Taqwa Fabrics Ltd. Libas Knitwear

16th April 2014

Observations

Tested Columns

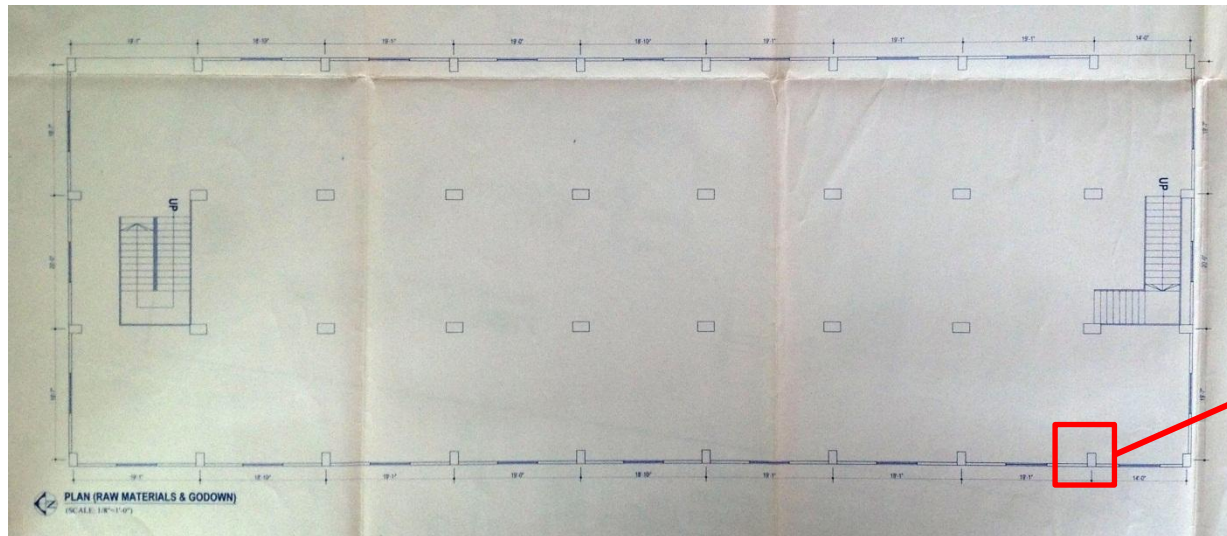
Stress levels in columns, with particular reference to internal column beneath 3-storey vertical extension to Packing Section of Main Building

Cursory calculations indicate that the working stress of the columns at Ground Floor levels of the Main Building are at a high level, particularly at the internal column beneath the 3-storey extension to the Packing Section. Detail Engineering Assessment required.

- Building Engineer to review design, loads and column stresses in structure.
- A **Detail Engineering Assessment** of Packing Section in Main Building is to be commenced – see attached scope.
- Verify insitu concrete stresses by taking 100mm diameter cores from min. 4 columns at ground floor level.

- Produce and actively manage a loading plan for all floor plates within the factory, giving consideration to floor capacity and column capacity.
- Detail Engineering Assessment to be completed.

Floor Plan of Raw Materials Godown Building (Extract from Sreepur-Municipality-approved Permit Drawing)

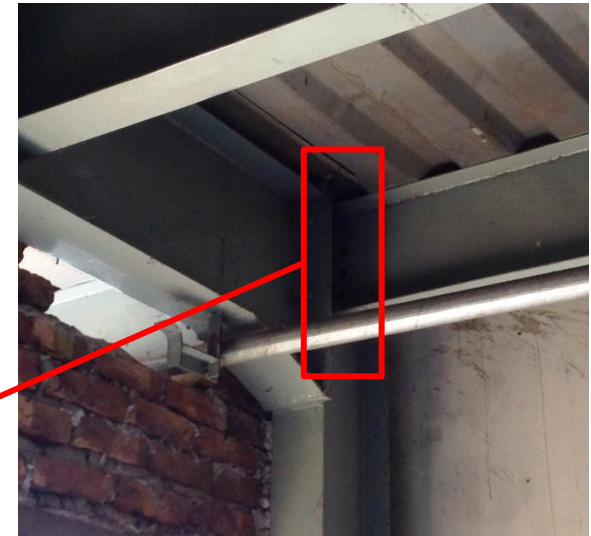
A number of bolts were observed to be missing at connections to the primary steelwork in the two-storey Raw Materials Godown Building. Special emphasis is drawn to the steel edge beam supporting the first floor, as identified below, where **all** bolts are missing at the column connection. It is not clear how the beam is adequately supported. Building Engineer to review all connections as a matter of urgency, and to carry out remedial works to the structure as required.

All bolts are missing at Edge Beam-to-Column Connection

Location of Connection Detail where all bolts are missing

- Provide temporary prop to end of steel beam. Building Engineer to ensure correct connection detail is designed, fabricated and installed on site.

Floor Plan of Dyeing Building (Extract from Permit Drawing)

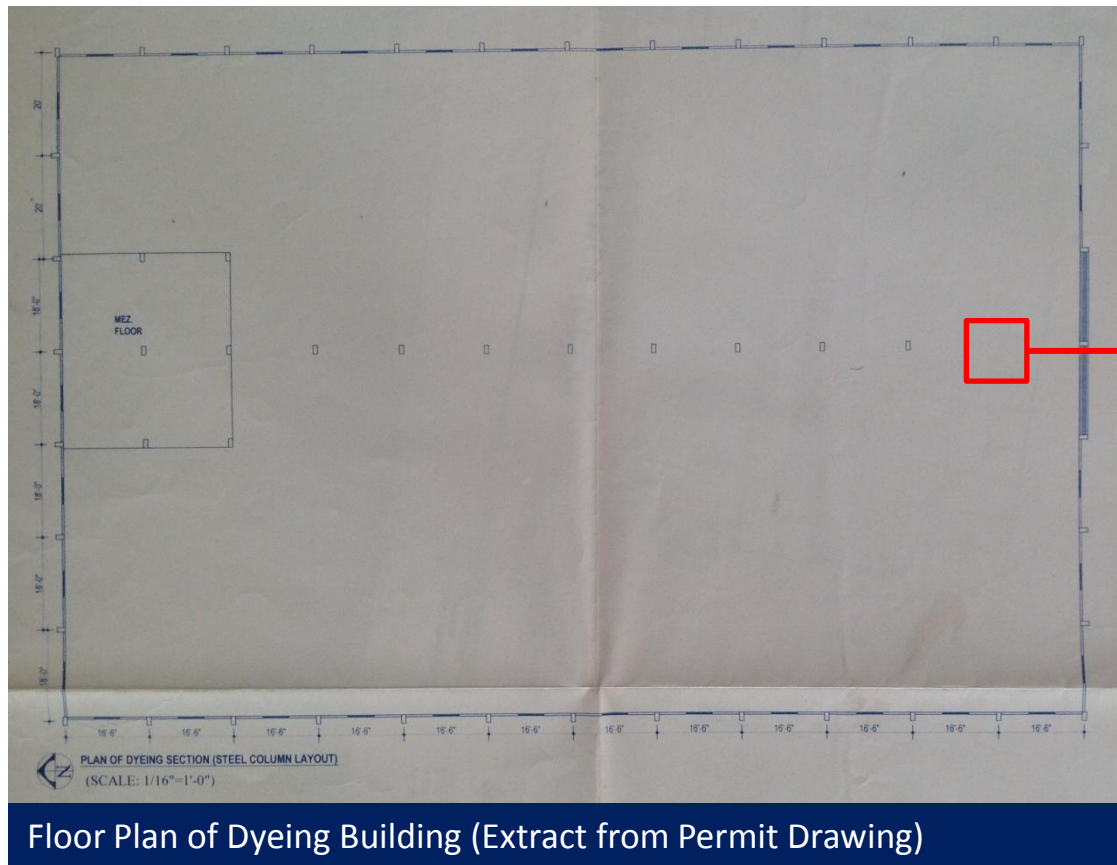
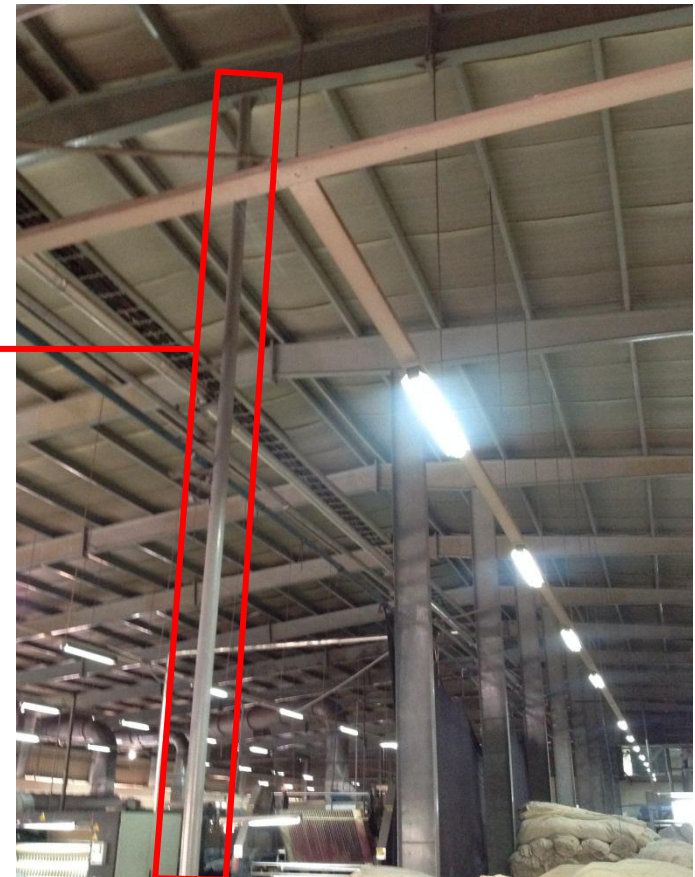
A slender circular hollow section was observed in the Dyeing Building, providing support to the rafter. This is not in accordance with the structural drawings, where a 450x150 I-section is typically shown. It does appear as if the column section is missing from the Sreepur Municipality-approved permit drawing (see below). Building Engineer to review design as a matter of urgency, and to carry out remedial works to the structure as required.

Location of Slender Column

Slender Column

- Building Engineer to check the design and capacity of the slender circular hollow section supporting the steel roof and make any necessary alterations.

Lack of edge protection at Roof Level of Main Building (5th and 6th Floor levels)

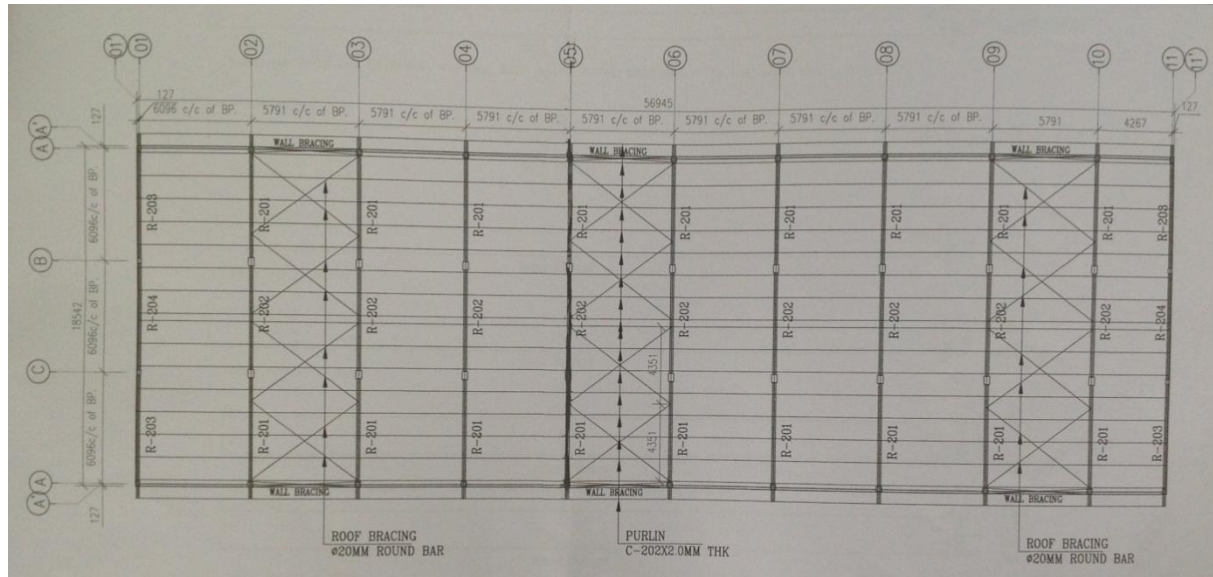
Perimeter With Edge Protection

Edge Protection Missing

- Provide immediate edge protection to both roof levels whilst construction work continues on site.

Main Building Layout – Original Permit Drawing

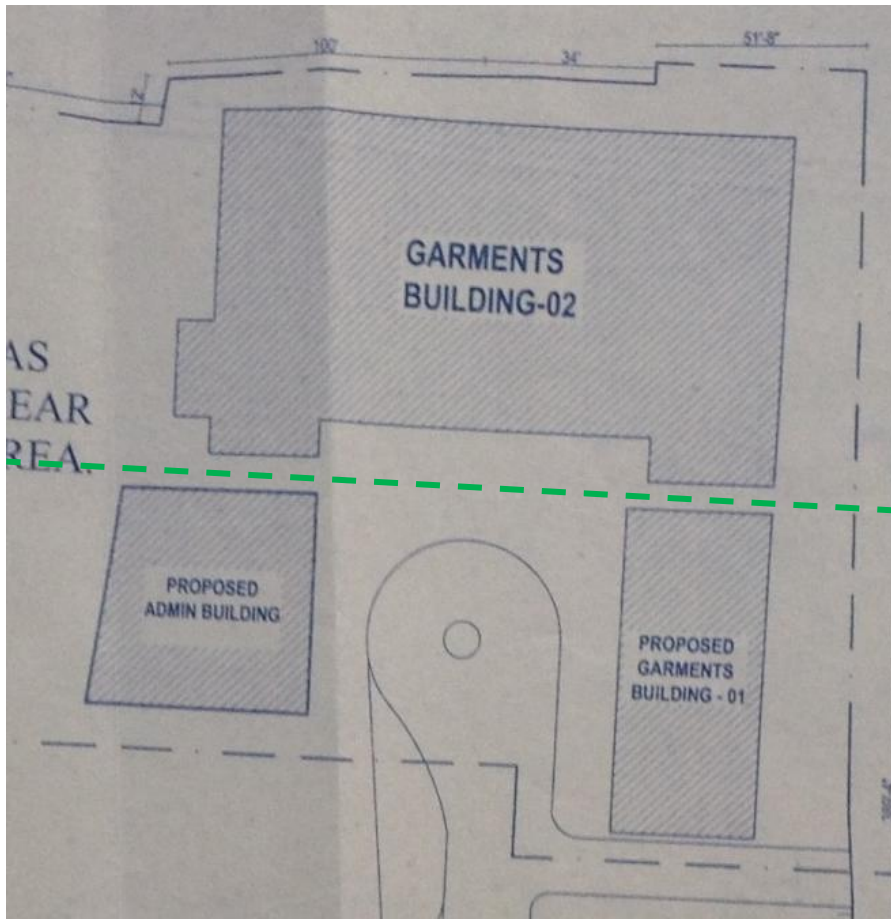
- The permit drawing and structural drawings show the Main Factory Building as three separate units, comprising the Packing Section, the Administration Section and the Central Factory Section. They are actually built as a single unit with a movement joint running through the Central Factory Section.
- A 3 storey extension has been added above the Packing Section of the Main Factory Building. This has not been approved, and the column beneath this extension is proving critical (refer to Item 1).
- The longitudinal bracing for the Raw Materials Godown Building is referenced in the drawings, but is missing on site.
- Inconsistencies in rebar quantities for the Main Building.

Building Engineer to review and provide clarification.

- Factory Engineer to survey the structure and prepare a full set of “as-constructed” drawings.

Main Building Layout – Permit for New Construction

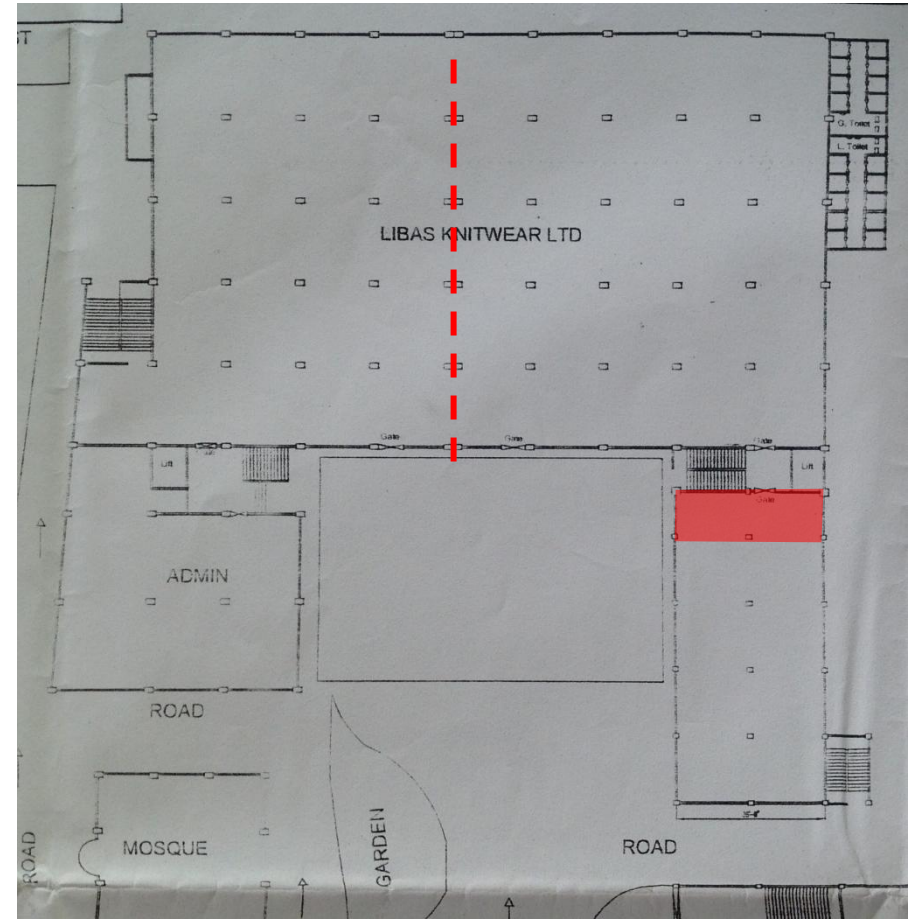
Original Location of Movement Joint

Extent of 3-storey vertical extension

Actual Location of Movement Joint

Typical Site Layout

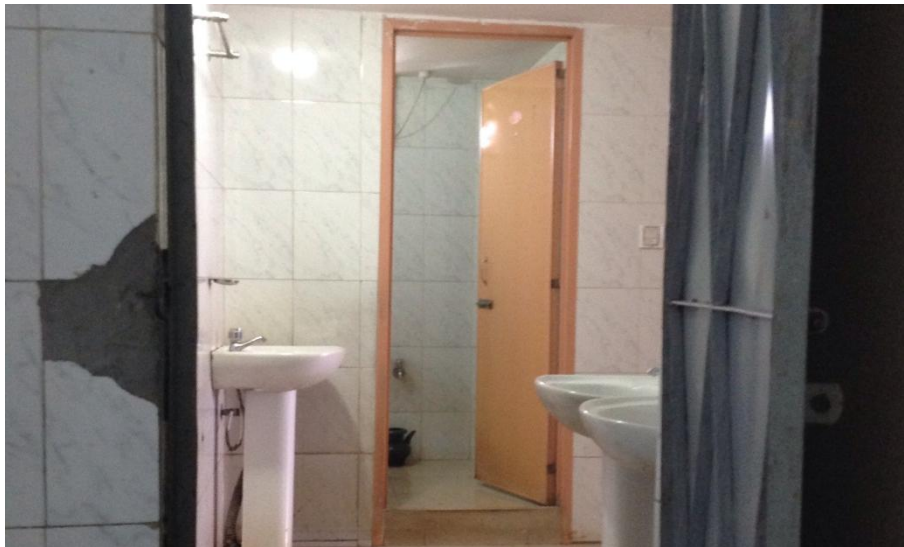
Areas of high loading were noted at the water tanks at roof level, the 1st Floor Finished Goods Storage area, and the toilets plinths and suspended ceiling slabs at all floors of the Main Building, and at the yarn storage area in the Knitting & Raw Materials Godown Building at 1st Floor level. Building Engineer to check that the different slab constructions have been adequately designed to accommodate this loading, particularly the 1st floor cantilever.

- Water Tanks at Roof Level
- 1st Floor Finished Goods Storage Area
- Extent of Toilet Plinths & Slabs to all Floors
- Yarn Storage at 1st Floor of RMG Building

- Factory Engineer to investigate the loading from water tanks, 1st floor storage area and toilet floor build-up (and slabs over) and advise on any necessary alterations taking account of floor capacity and column capacity.

- Implement actions arising from investigation.

Dining Area Shed

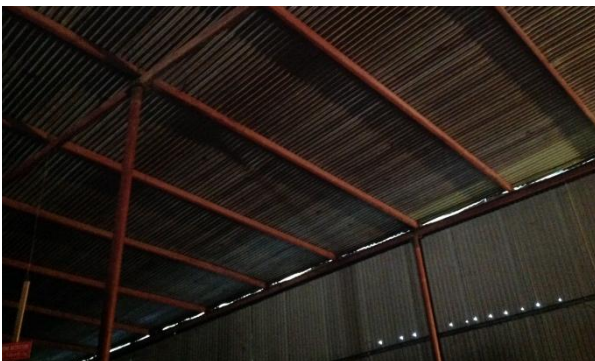
The factory compound includes a number of lightweight structures, namely the Dining Shed, the Leftover Storage Shed, the Staff Compound, the Chemical Storage Shed and the Boiler Room, all of which are outside of the main factory building at ground floor level. These structures, which include lightweight roofs on steel or RC columns, do not appear to be engineered. Building Engineer to review the design of these structures, with special emphasis on connections and bracing, and to implement any upgrade works as required.

Dining Shed Connection Detail

- Building Engineer to check the design and capacity of the lightweight roof structures/connection details and make any necessary alterations.

Ground Floor Plan

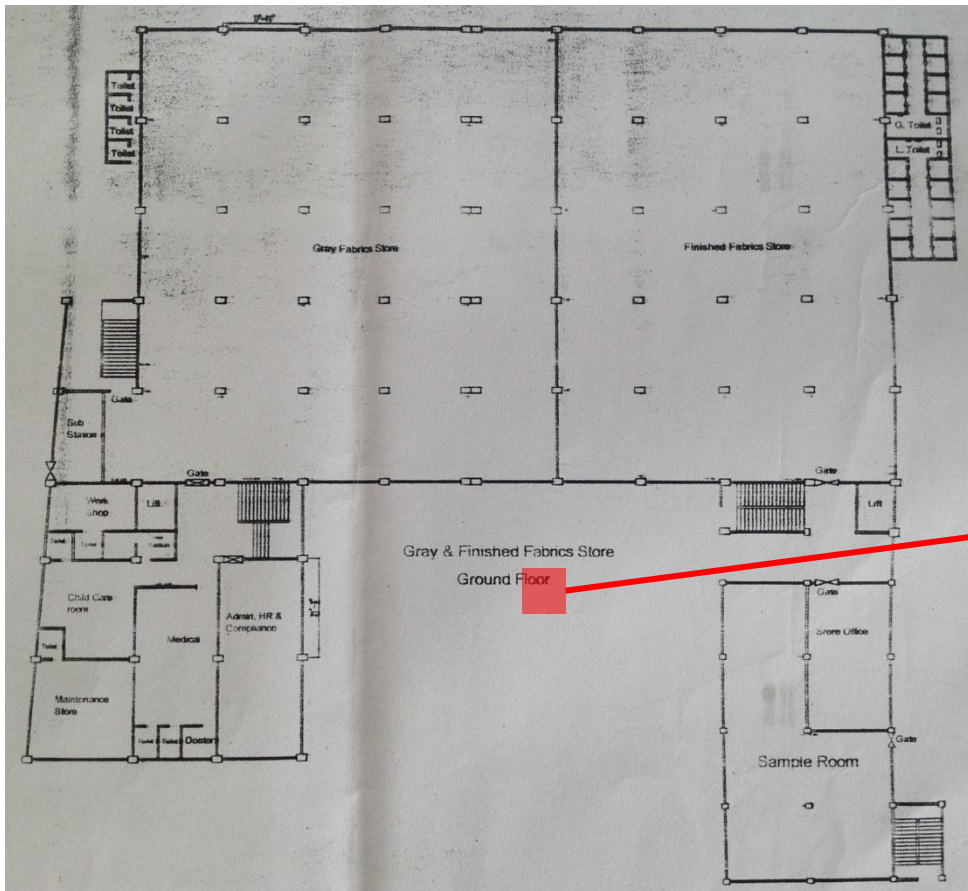
The central column at the delivery entrance to the Main Building is at risk of being accidentally struck by a vehicle. Building Engineer to check that the column has been adequately designed for impact loading, and to ensure that adequate protection is provided.

Column at risk of impact loading

- Building Engineer to check if the column has been adequately designed for impact loading, and to ensure that adequate protection is provided.
